**Meeting of the Central Valley Flood Protection Board
September 28, 2012
Staff Report – Encroachment Permit
Burlington Northern Santa Fe Railroad
Lone Tree Creek Railroad Bridge Replacement, San Joaquin County**

To consider Board approval of Permit No. 18768.

The applicant proposes to replace the existing 70 foot long timber BNSF Railroad Bridge No. 1104.6 over Lone Tree Creek with a new 83 foot long by 20 foot wide flat-slab concrete bridge. The proposed bridge will only have three sets of piles in Lone Tree Creek as compared to four sets of piles for the existing bridge. New concrete abutments are also proposed at each end of the new bridge. Also proposed is rip rap along the creek bed and slopes for erosion protection 20 feet north and south of the bridge, along with rip rap protection underneath the new bridge (See Attachment B for general and pile plans for the new bridge).

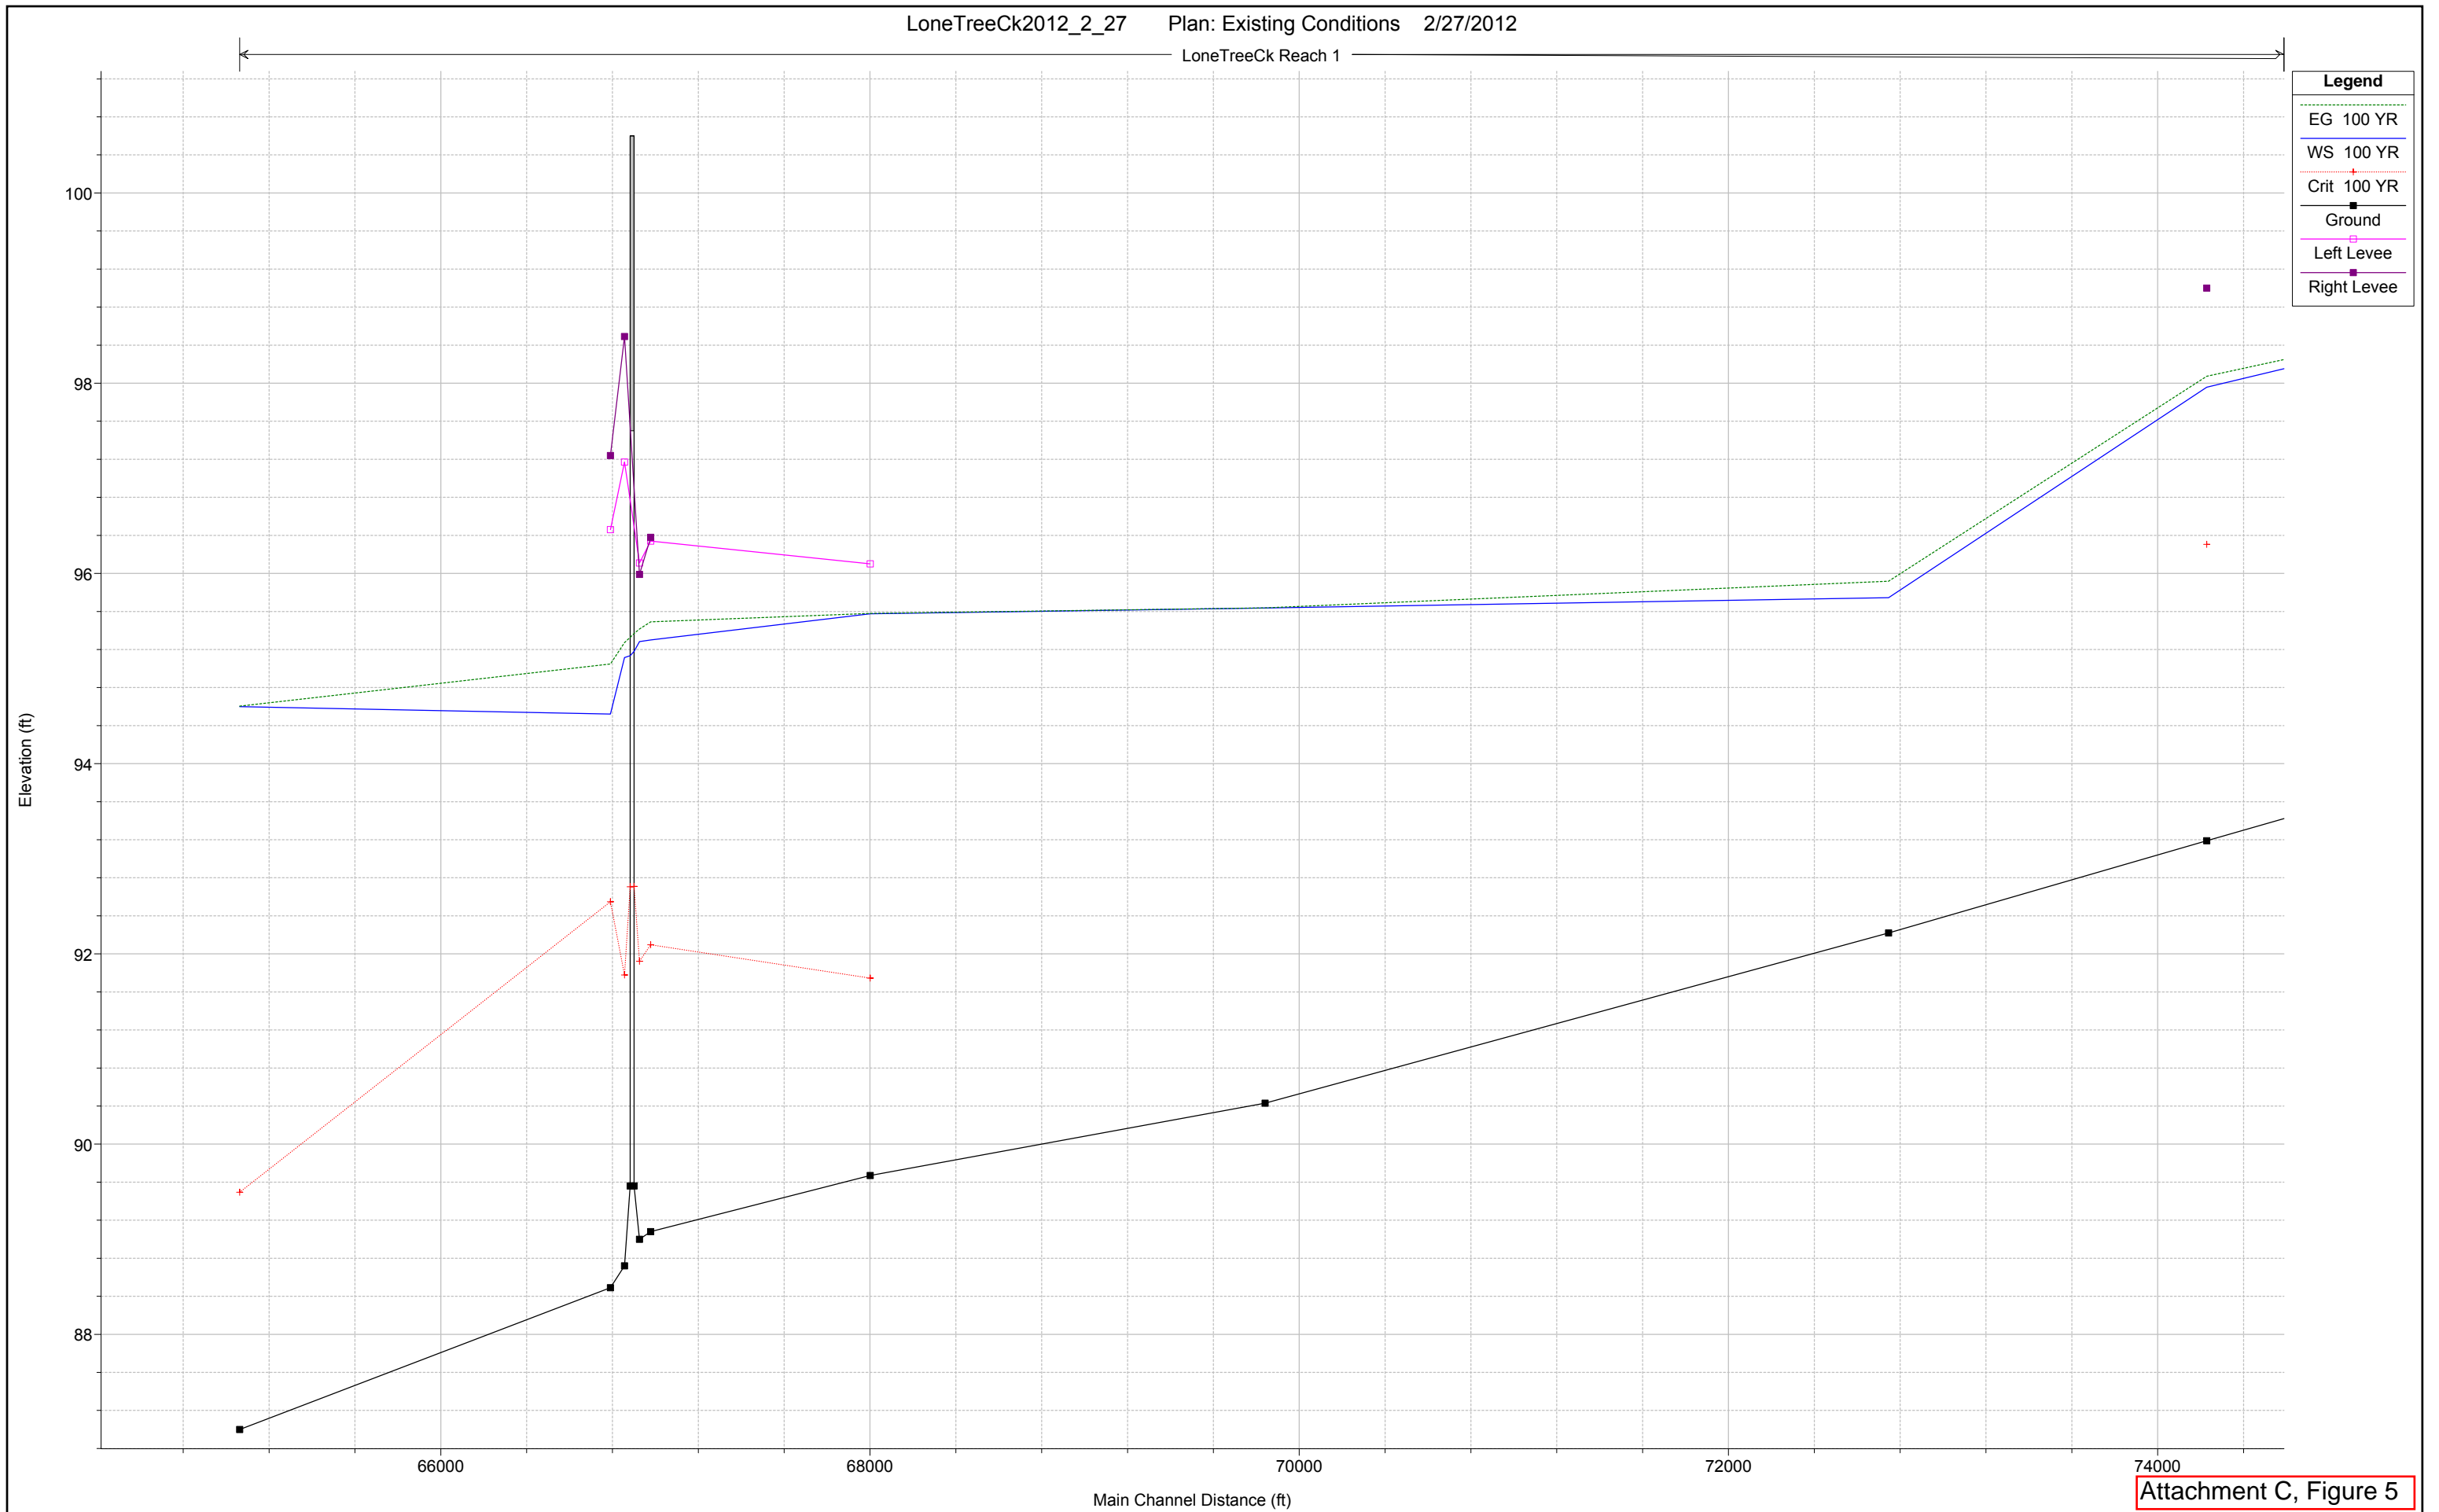
At 1,000 feet upstream of the bridge, the design existing condition WSE is 0.5 feet below the top of the left bank per Attachment C, Figure 5. The proposed condition WSE is 0.7 feet below the top of the left bank per Attachment C, Figure 6. Although the hydraulic situation would be improving with the proposed project, the applicant should understand that they may have some responsibility to monitor this area during design storm events to prevent possible flood damages to adjacent property owners.

Attachment D, Figure 2

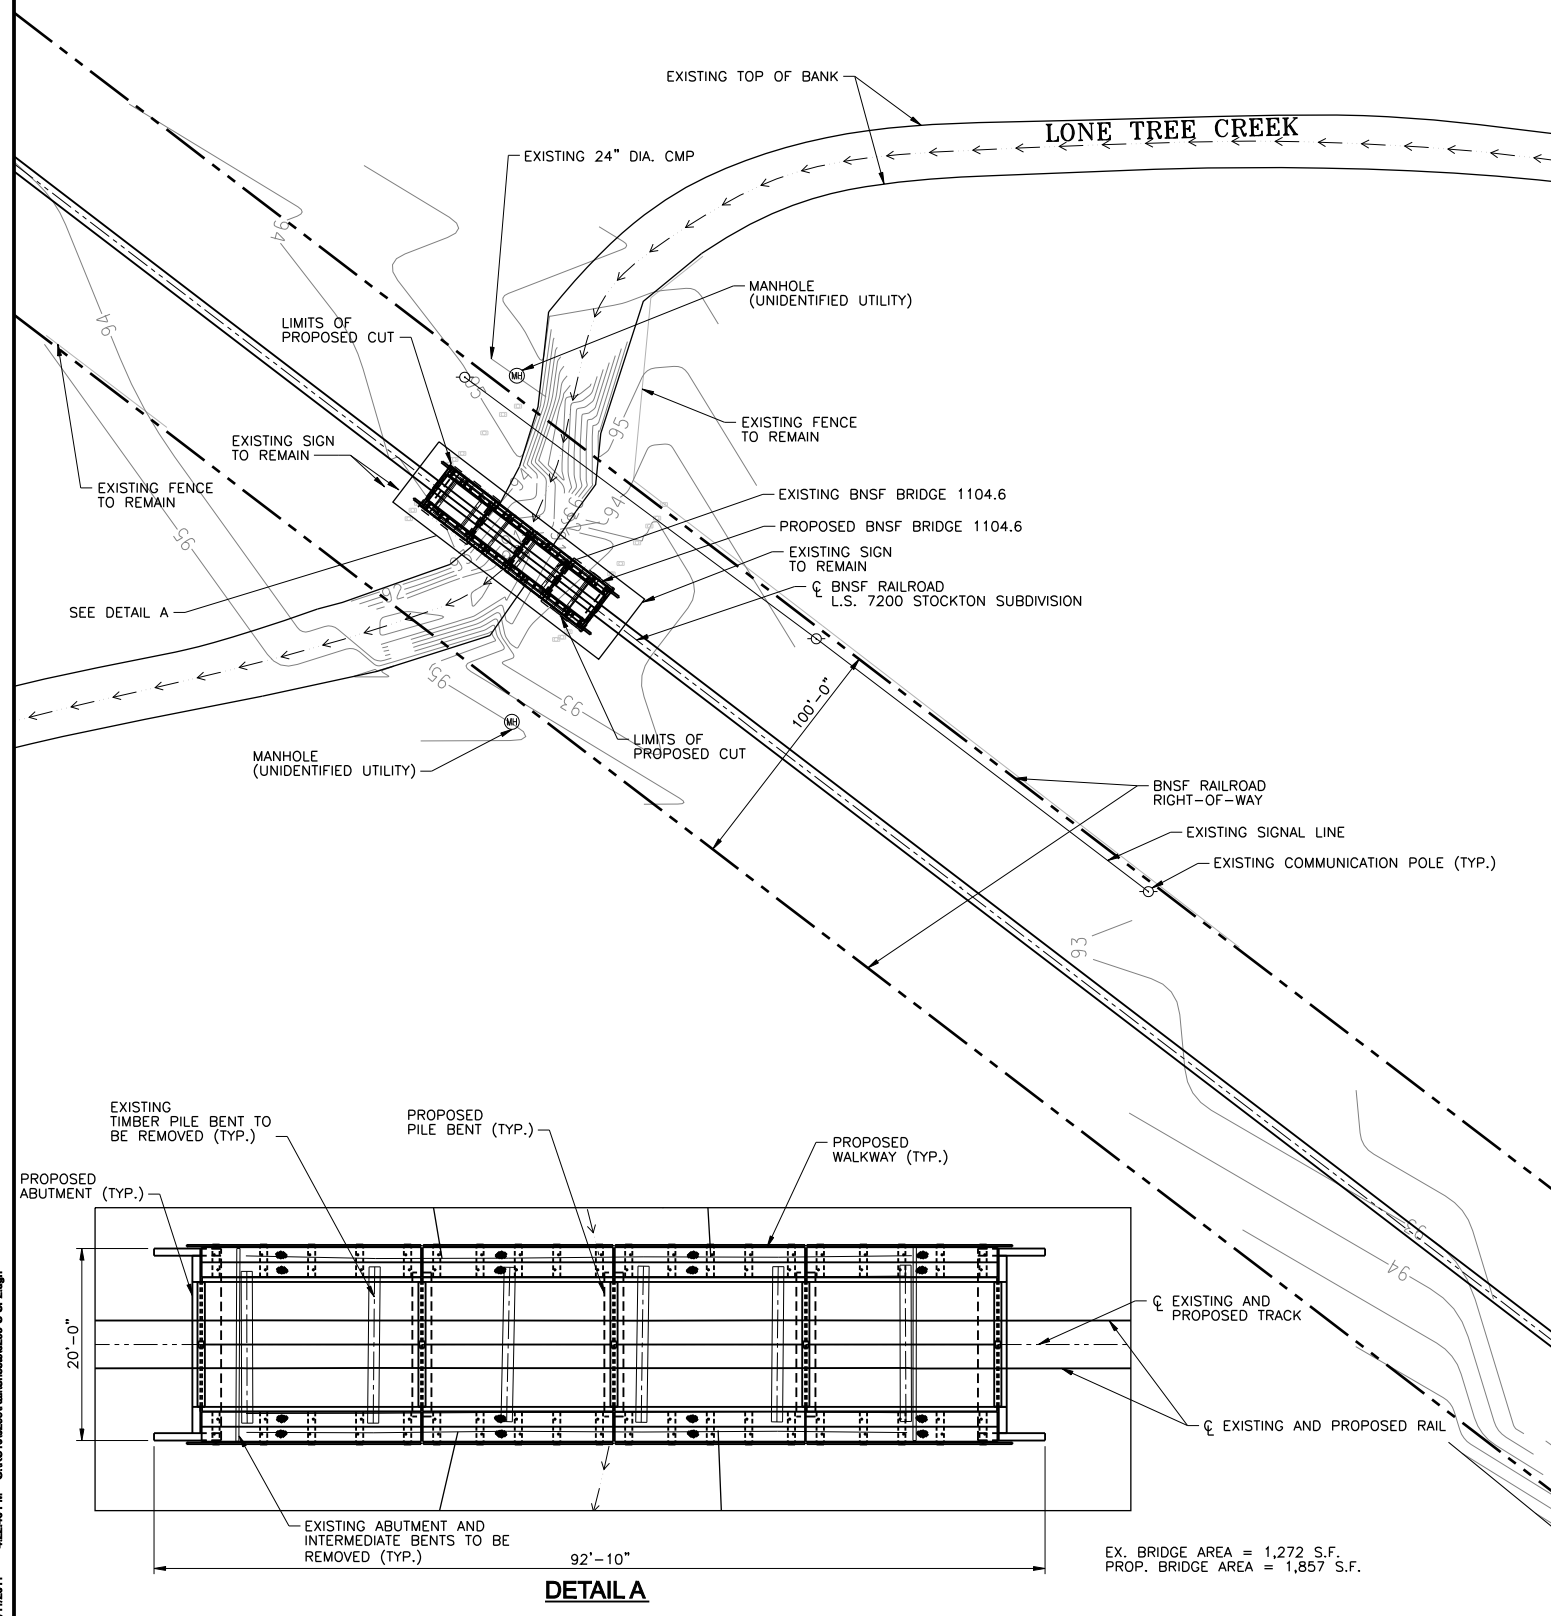
Because of these drainage concerns, the CVFPB is requiring BNSF Railroad to submit a more detailed drainage plan of the rip rap placement area under the bridge, and for 20 feet on each side of the bridge. For our review, and as part of the permitting process, the plan should show the existing drainage pipes in the area and how BNSF is going to maintain this drainage in the future.

Please include in this additional and more detailed drainage plan, the two existing manholes with a 24-inch diameter corrugated metal pipe, as shown on the site plan for this bridge replacement. Also include the drainage pipes near the bridge, as shown in Photographs Nos. 1 and 7, which were submitted with this permit application. We also recommend that you contact the Dorosh's to fully understand their flooding concerns and address them appropriately in this more detailed drainage plan.
